**TESORO  
LOS ANGELES REFINERY  
INTEGRATION AND COMPLIANCE PROJECT  
FINAL  
ENVIRONMENTAL IMPACT REPORT**

**VOLUME IV: Appendix G (Appendix G0 – Response G1-74.8)**

### **Response to Comments**

**Figure G0-2.15-1**  
**Historical Number of PRVs Added to the Flare Gas Recovery System and Historical Flaring Emissions for the Tesoro Los Angeles Refinery (2007-2015)**

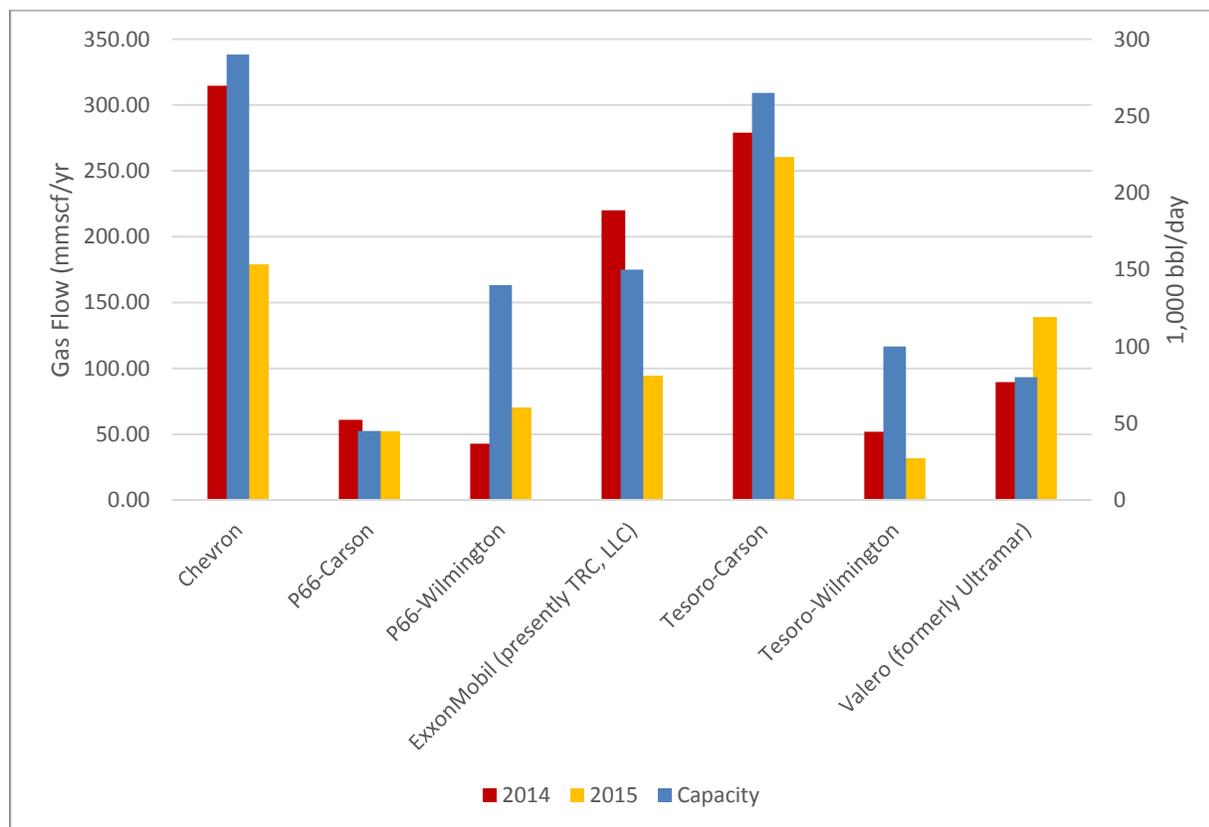
Commenters have suggested that increasing the number of PRVs connected to the flare and flare gas recovery system would result in an increase in emissions from the flare. Some have suggested that the potential 6,000 bbl crude oil capacity increase will also increase flaring. In fact, data for the Refinery shows that flaring events happen independently of the number of PRVs or the amount of crude oil processed. Between 2007 and 2015, approximately 90 PRVs were newly connected to the flare and flare gas recovery system. As shown in Figure G0-2.15-1, the emissions from flaring have decreased over the same time period and have no correlation to increasing number of PRVs connected to the flare and flare gas recovery system. Additionally, the proposed project includes the shutdown of the Wilmington Operations FCCU, which

includes removing 44 PRVs from service so that they will no longer have the potential to generate emissions from the flare. As for the relationship between the amount of barrels per day processed and flare gas flow, Figure G0-2.15-2 shows no correlation.
